To: T10 Technical Committee  
From: Rob Elliott, HP (elliott@hp.com)  
Date: 4 July 2006  
Subject: 06-281r1 SAS-2 Enable and disable zoning

#### **Suggested changes to sas2r04a as modified by 06-279r1**

**Figure 5 — Physical presence detection extending a ZPSDS example**

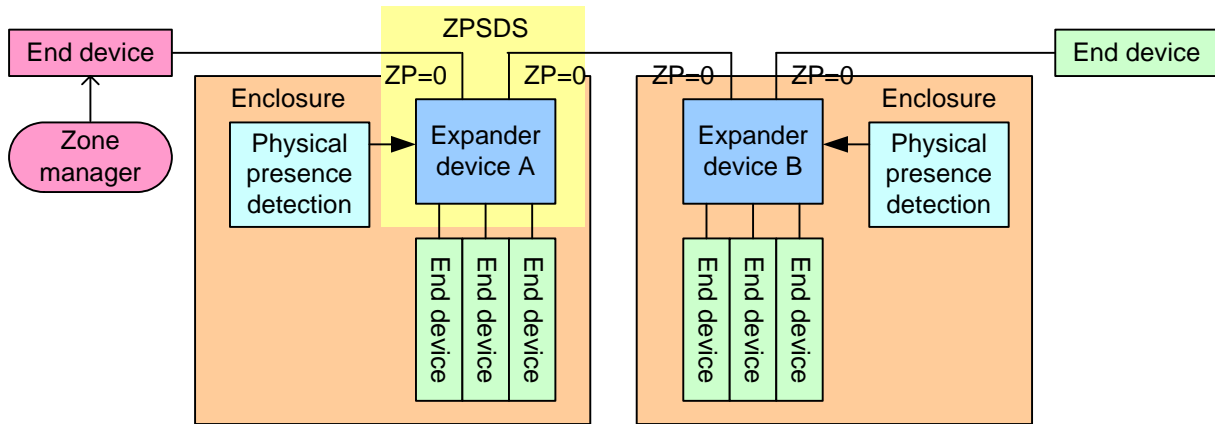
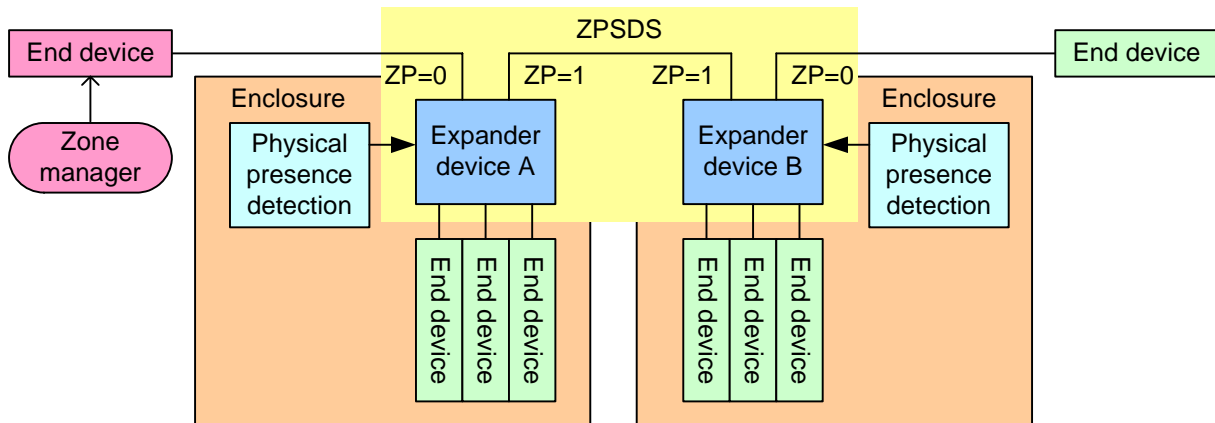
Figure 5 shows an example of two enclosures with physical presence detection where zoning is enabled in the expander device in the left enclosure, but is not enabled in the expander devices in the right enclosure. The zone manager is able to configure zoning in zoning expander device A because the zone group of its SMP initiator port has access to zone group 2. However, it is not able to configure zoning in expander device B unless physical presence is asserted.

- 1) configures zone phy information in each expander device, including setting the ZONE PARTICIPATING bit to one in each expander phy that is going to be inside the ZPSDS; and
- 2) sends a CONFIGURE ZONING request with the ZONING ENABLED bit set to zero to expander device B while physical presence is asserted.

**Figure 6 — Physical presence detection overtaking a ZPSDS example**

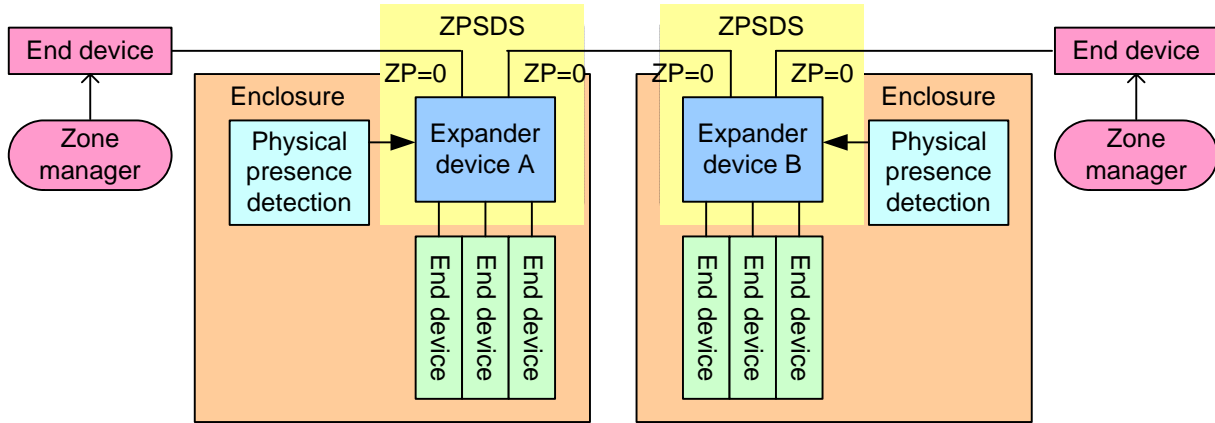
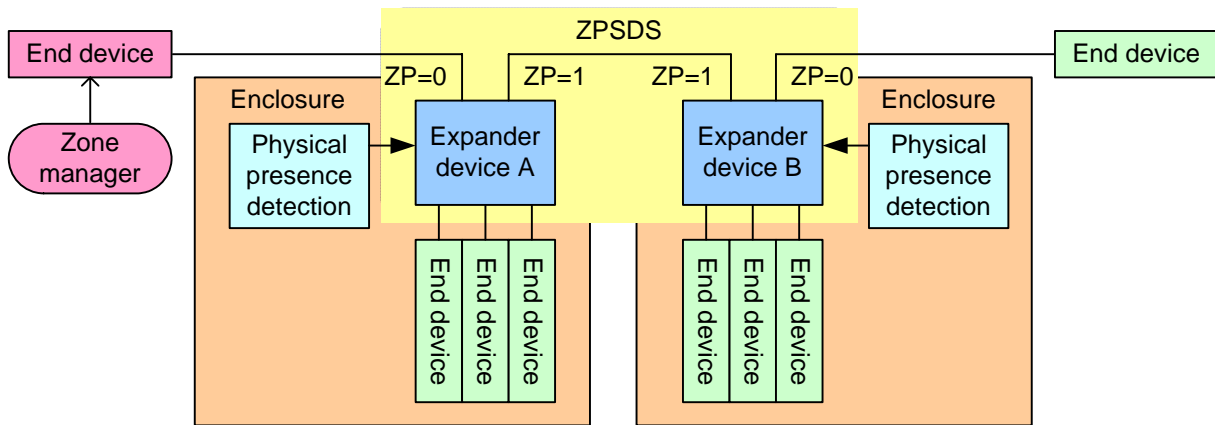
Figure 6 shows an example of two enclosures with physical presence detection where zoning is enabled in both the expander devices. The zone manager is able to configure zoning in zoning expander device A.

[because the zone group of its SMP initiator port has access to zone group 2. However, it is not able to configure zoning in expander device B unless physical presence is asserted.](#)

- 1) sends a CONFIGURE ZONING request with the ZONING ENABLED bit set to zero to expander device B while physical presence is asserted;
- 2) configures zone phy information in each expander device, including setting the ZONE PARTICIPATING bit to one in each expander phy that is going to be inside the ZPSDS; and
- 3) sends a CONFIGURE ZONING request with the ZONING ENABLED bit set to zero to expander device B while physical presence is asserted
